**PLANNED UNIT DEVELOPMENT  
STAFF REPORT****Date: September 6, 2012****DEVELOPMENT NAME**

Chinnis Holdings LLC

**LOCATION**5401 Cottage Hill Road  
(Southwest corner of Cottage Hill Road and Vivian Drive)**CITY COUNCIL  
DISTRICT**

Planned Unit Development Approval to amend a previously approved Planned Unit Development to allow shared access between two building sites to include an 8' X 20' trailer.

# SITE PLAN

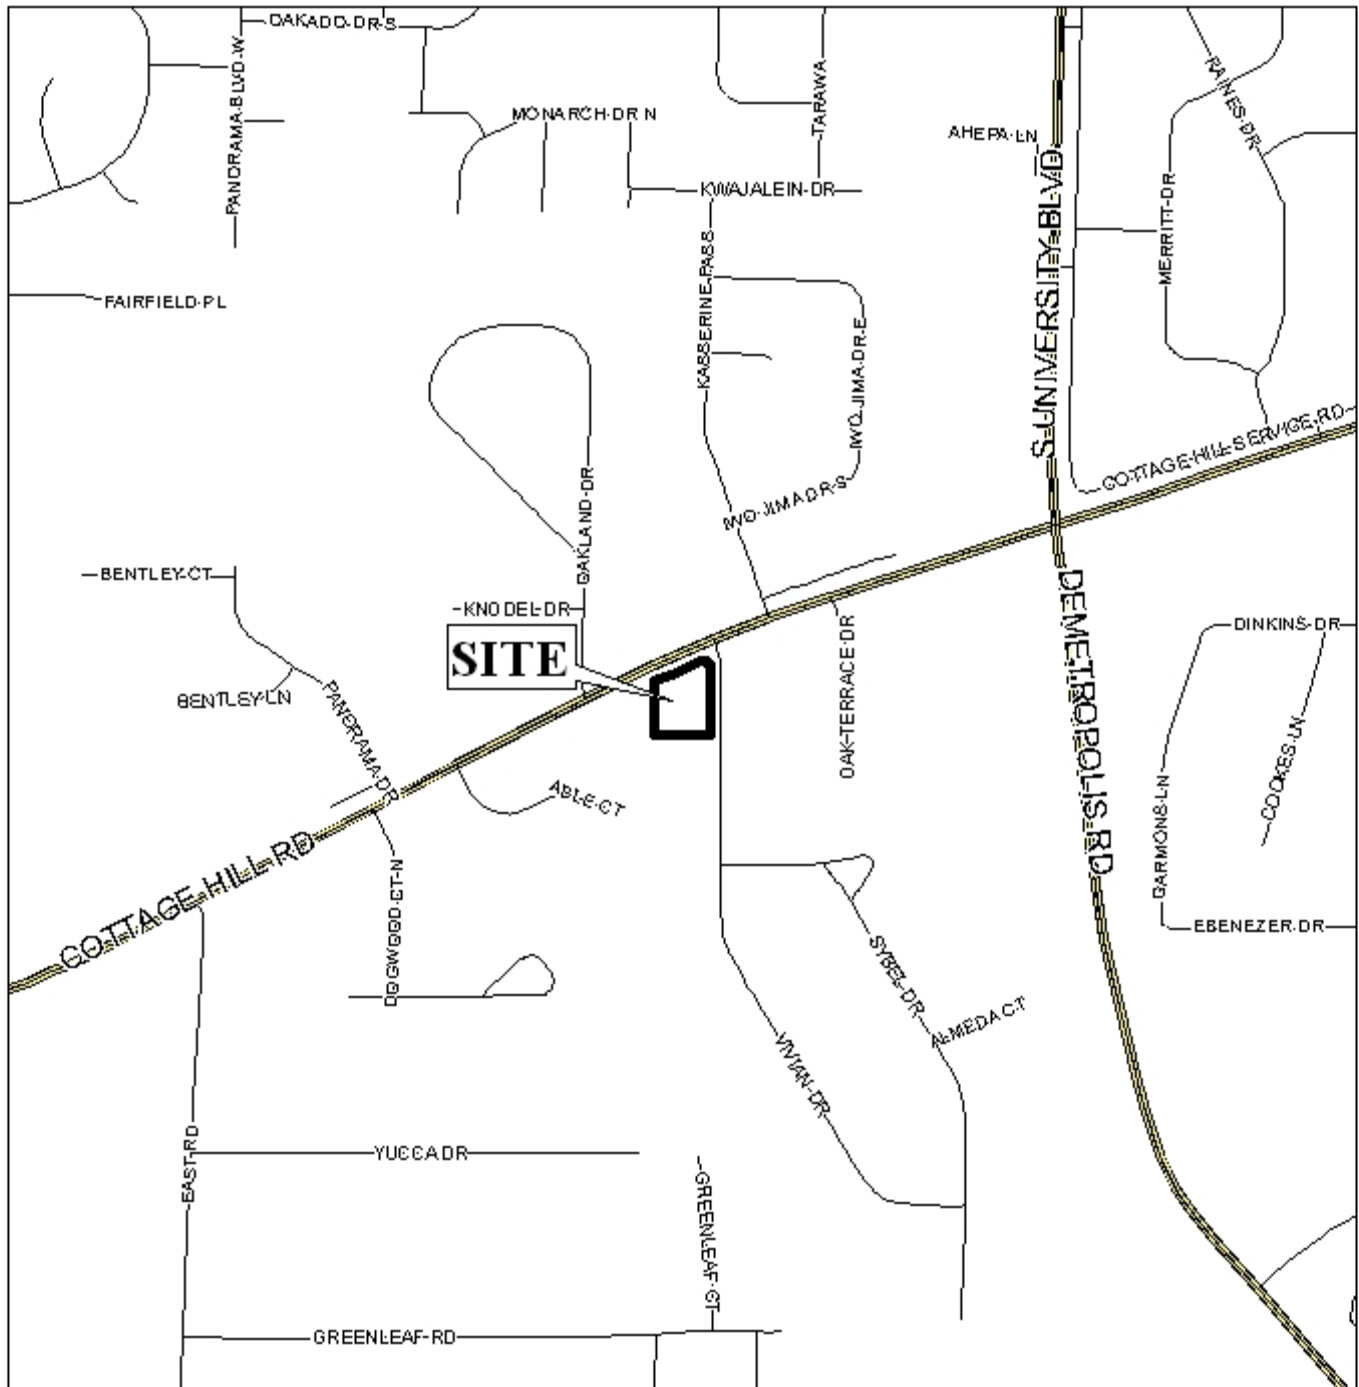
The parking layout along Cottage Hill Rd should be illustrated in a straight line parallel with the building and driving aisle, and not parallel with the roadway right-of-way. As illustrated the first space nearest the Cottage Hill Rd driveway is non-standard length, and the three spaces nearest the Vivian Dr driveway require excessive backing to exit the spaces. As noted, the driveway size, location and design are to be approved by Traffic Engineering and conform to AASHTO standards. Driveway radii are not shown; a 20' radius is

typical for passenger cars and a 30' radius is desirable for large trucks. The site plan does not include sidewalk along either roadway frontage.

The site plan now under consideration includes modification of the existing parking area to eliminate the continuous curb-cut along Vivian Drive, with two 24-foot wide curb-cuts along Vivian Drive to remain. The proposed barbecue trailer will be parked in the front parking area, with parking adjusted to accommodate the trailer. It appears that the trailer will be parked on new landscape area. The site plan also depicts three new handicap parking spaces, a dumpster, and a total of 49 parking spaces.

There are several deficiencies regarding the provided site plan and associated information. First, there is no information regarding the existing or proposed uses in the buildings, including the total gross square feet of the building and by use: staff cannot determine the total amount of required parking.

The proposed location of the barbecue trailer results in a modified front parking area that creates parking spaces of various alignments. As commented by Traffic Engineering, the parking spaces facing Cottage Hill Road should be realigned to be parallel to the parking spaces facing the building, providing a uniform row of parking. Also, the trailer itself should not be placed on an unpaved area. The site plan should be revised to realign the parking and depict the trailer on an asphalt or concrete surface.

It appears that a dumpster is proposed to be located within the building setback line along Vivian Drive, in a landscape area. Dumpsters must meet all required building setbacks and must be enclosed on three sides by a fence or wall, located on a dumpster pad, and be situated so that servicing of the dumpster occurs entirely on private property. Furthermore, all dumpsters must now be connected to the sanitary sewer system and include a grease trap. The site plan should be revised to show the dumpster relocated to meet all setbacks, be serviceable by a truck completely on private property, and to have a connection via a grease trap to the sanitary sewer.

The site plan includes the area dedicated to the City of Mobile for the Vivian Drive right-of-way. The site plan should no longer include any dedicated land as part of the site, and instead this area should now just be a part of the right-of-way for Vivian Drive, with the right-of-way width revised to reflect the dedication.

It is apparent that vehicles are parking in landscape areas. Provisions should be shown on the site plan to prevent vehicles from maneuvering in landscape areas, including the provision of curbs or parking bumpers.

Landscape areas are shown on the site plan, but no quantitative information is provided regarding how much landscape area is provided. The site plan should include total landscape area in square feet, and total frontage landscape area in square feet. Urban Forestry has

additionally requested compliance with the frontage tree requirements of the Zoning Ordinance. Therefore the site plan should be revised to depict frontage tree compliance, and should depict any existing trees within the frontage area that will remain and be claimed for credit.

Finally, the site plan depicts three proposed handicap accessible parking spaces. The Americans with Disabilities Act requires at least one of the spaces to be van accessible, and requires all spaces to be properly signed. None of the proposed spaces appear to meet van accessibility requirements, and their location does not appear to be near any ramp that allows clear access into the tenant spaces. The site plan should be revised to comply with all applicable federal laws regarding handicap accessibility, as Planned Unit Development approval is site plan specific, and any redesign of the parking area will change the site plan.

**Planned Unit Development:** Based upon the preceding, this application is recommended for Holdover until the October 4<sup>th</sup> meeting, with revisions provided to the Planning Section by September 14<sup>th</sup>, so that the following modifications can be made to the site plan:

- 1) Revision of the site plan to include or submittal of a listing of all existing and proposed uses on the site, listed by suite number and by square feet;

- 2) Revision of the front parking area to reflect Traffic Engineering comments (*The parking layout along Cottage Hill Rd should be illustrated in a straight line parallel with the building and driving aisle, and not parallel with the roadway right-of-way. As illustrated the first space nearest the Cottage Hill Rd driveway is non-standard length, and the three spaces nearest the Vivian Dr driveway require excessive backing to exit the spaces. As noted, the driveway size, location and design are to be approved by Traffic Engineering and conform to AASHTO standards. Driveway radii are not shown; a 20' radius is typical for passenger cars and a 30' radius is desirable for large trucks. The site plan does not include sidewalk along either roadway frontage.*), and to ensure that the front parking area consists of uniform rows of parking;

- 3) Revision of the site plan to place the barbeque trailer on a concrete or asphalt paved surface;
- 4) Revision of the site plan to relocate the proposed dumpster and enclosure to be on a dumpster pad connected to sanitary sewer via a grease trap, meeting all required setbacks, and providing adequate room for dumpster servicing on site;

- 5) Revision of the site plan to properly show the right-of-way width of Vivian Drive reflecting the previous dedication, and depiction of the property line to reflect dedication;

- 6) Provision of parking bumpers or curbing as necessary to prevent vehicles from being parked in landscape areas, and depiction of said curbing or bumpers on the site plan;

- 7) Revision of the site plan to provide landscape area quantities in square feet for both overall and frontage landscape areas;
- 8) Revision of the site plan to depict frontage tree compliance as required by Urban Forestry comments (*Property to be developed in compliance with state and local laws that pertain to tree preservation and protection on both city and private properties (State Act 61-929 and City Code Chapters 57 and 64). Full compliance with frontage tree requirements of the Zoning Ordinance to be coordinated with Urban Forestry.*), as well as the location, size and species of any existing trees on the site;

- 10) Revision of the site plan to show handicap parking spaces that comply with any requirements of the Americans with Disabilities Act (*for example, ensure that one of the spaces is "van accessible," that all spaces are appropriately signed, and that an accessible route is provided to all tenant spaces*).
